November 3, 2020

RE: **Lot 10 Block 1 Volcano Cliffs Unit 22 SAD 228
8008 Alto Rey NW
Grading and Drainage Plan
Engineers Stamp Date 10/29/2020 (D10D003N10)**

GRADING AND DRAINAGE PLAN

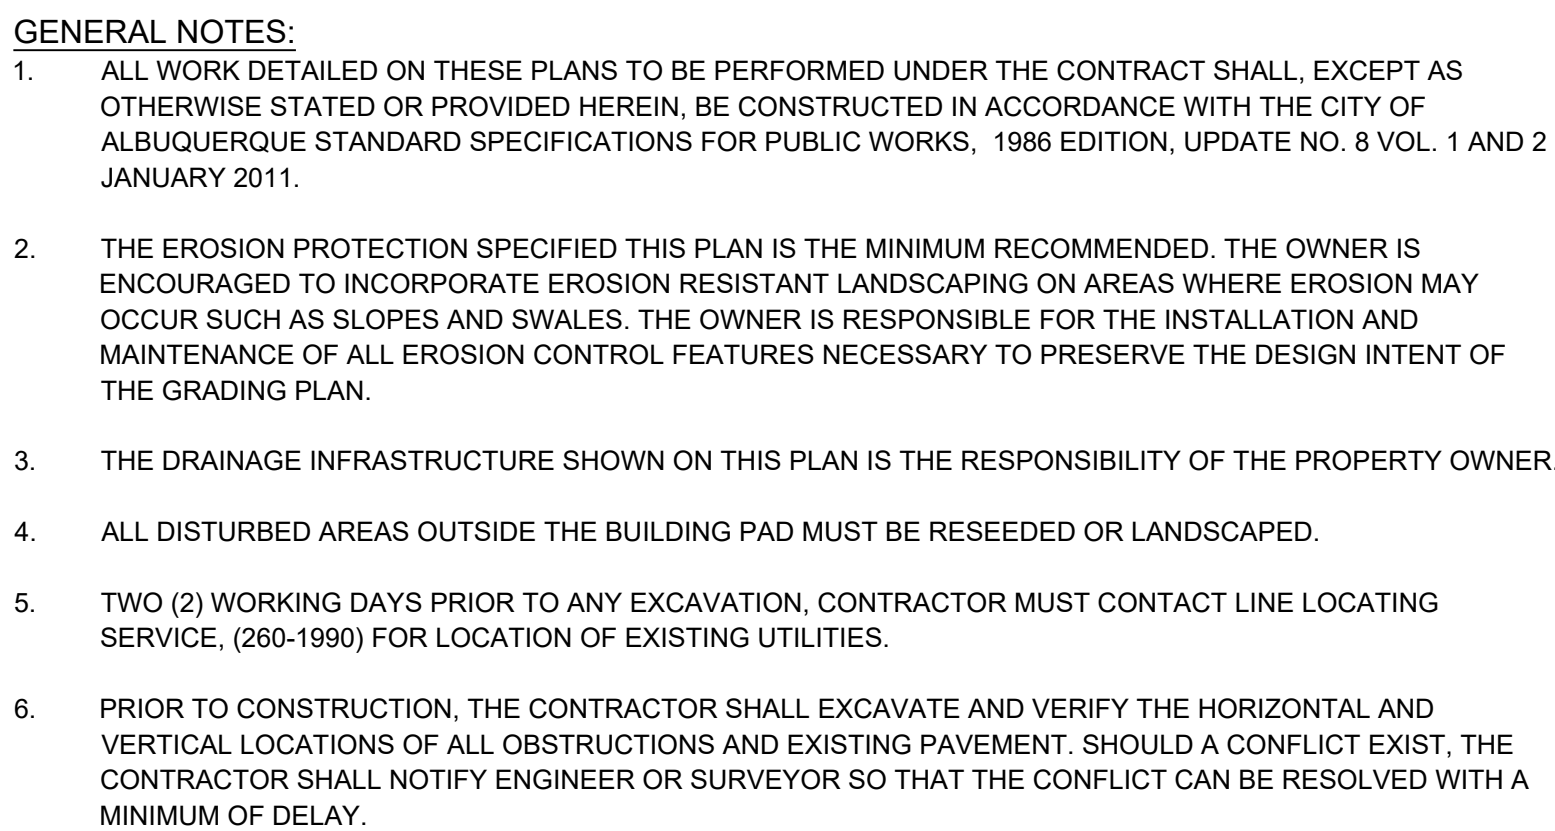
Based upon the information provided in your submittal received 11/2/2020, this plan is approved for Grading Permit.

Prior to Building permit approval a Pad Certification will be required, provided by the Engineer or a registered Land Surveyor.

Reiterate to the Owner/Contractor that a separate permit for a garden/retaining wall must be obtained with the approved G&D plan and Pad Certification. **Also, if a swimming pool is to be placed the grading and drainage plan will change and will need to be resubmitted.**

Prior to Certificate of Occupancy release, Engineer Certification per the DPM checklist will be required.
